CAA Operational Assessment

Title of airspace change proposal	Enabling T&E activity of Protector in UK airspace Spring/Summer 2024
Change sponsor	Ministry of Defence (MOD)
Project reference	ACP-2023-047
Account Manager	[REDACTED]
Case study commencement date	17 Jan 24
Case study report as at	5 February 2024
<p><i>Instructions</i></p> <p>In providing a response for each question, please ensure that the 'status' column is completed using the following options:</p> <ul style="list-style-type: none"> • YES • NO • PARTIALLY • N/A <p>To aid the SARG Lead it may be useful that each question is also highlighted accordingly to illustrate what is:</p> <p>resolved YES not resolved PARTIALLY not compliant NO</p>

Figure 1 - RAF Marham TDA Design

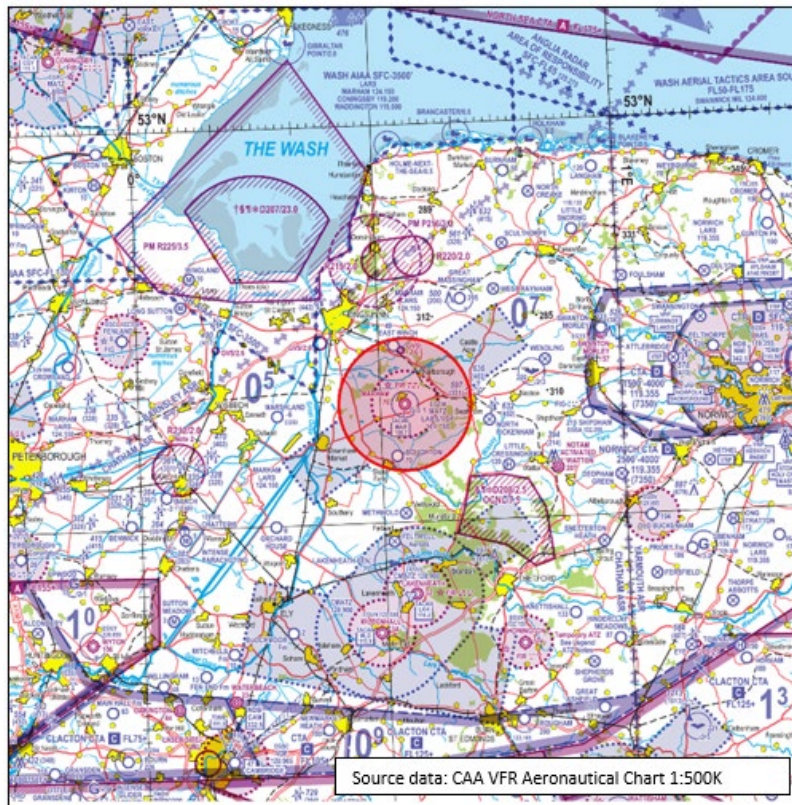
2.8	Is the evidence that the airspace design is compliant with ICAO SARPs, airspace design & FUA regulations, and Eurocontrol guidance satisfactory?	Yes
	The initial design of the proposed airspace was for the introduction of a single TDA from SFC to FL195. In response to stakeholder feedback, and in the interests of FUA, the proposed structure has been divided in 2 at an altitude of FL105. This enables traffic to transit one of the TDAs while Protector is operating within the other, potentially halving the duration of impact to other airspace users.

The proposed TDA structure lies in close proximity to EGD208 and creates a gap of approximately 2.4nm between the 2 structures. At present, this gap exists between the RAF Marham MATZ (which has the same lateral dimensions as the proposed TDA) and EGD208, and analysis shows that minor funnelling occurs through this gap as a result of some GA deciding to avoid the MATZ airspace. If approved for implementation, when the TDA is notified as active, this funnelling effect may be increased. However, analysis suggests the number of aircraft affected to be negligible, with a possible increase of 1 track per day likely.

Recommendation: As a consequence of activation of the proposed TDA and its proximity to EGD208, the minor funnelling effect currently experienced between the RAF Marham MATZ and EGD208 could be increased. While this effect is expected to be minimal, it is recommended that LARS is made available at all times when the TDA is active in order to provide additional mitigation.

Figure 2 - RAF Marham SWNE² TDA Cross-section

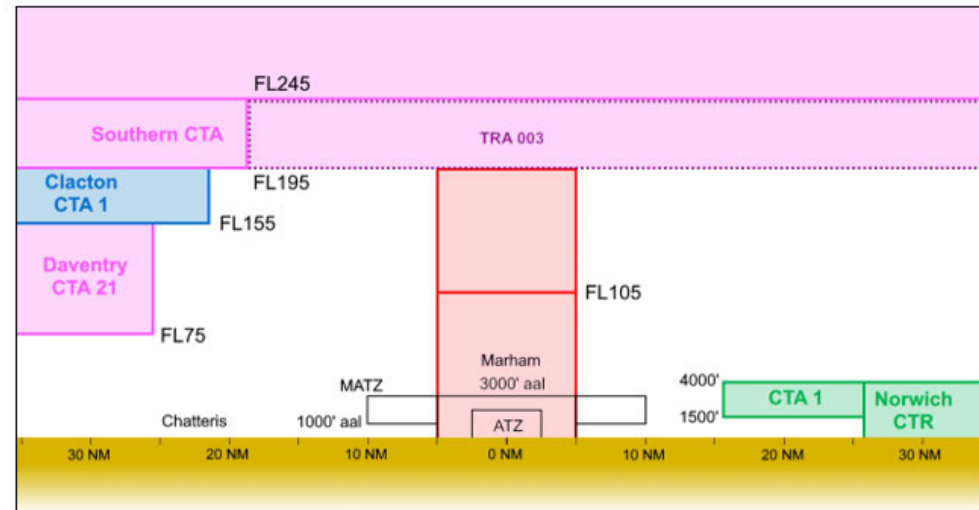
2.10	Within the constraints of safety and efficiency, does the airspace classification permit access to as many classes of user as practicable?	YES
	<p>Introduction of TDAs for the purposes of an airspace trial.</p> <p>The sponsor has stated a DACS will be available for the duration of all activation periods, thereby ensuring continued access to the airspace for all users unless the TDA volume is occupied by Protector. When occupied by Protector, regulation requires segregation, so all civilian airspace users will be required to remain outside of the TDA until Protector has cleared the relevant segment. In order to reduce the duration of this impact, the TDA has been divided into 2 segments, one from SFC to FL105, the other from FL105 to FL195.</p>
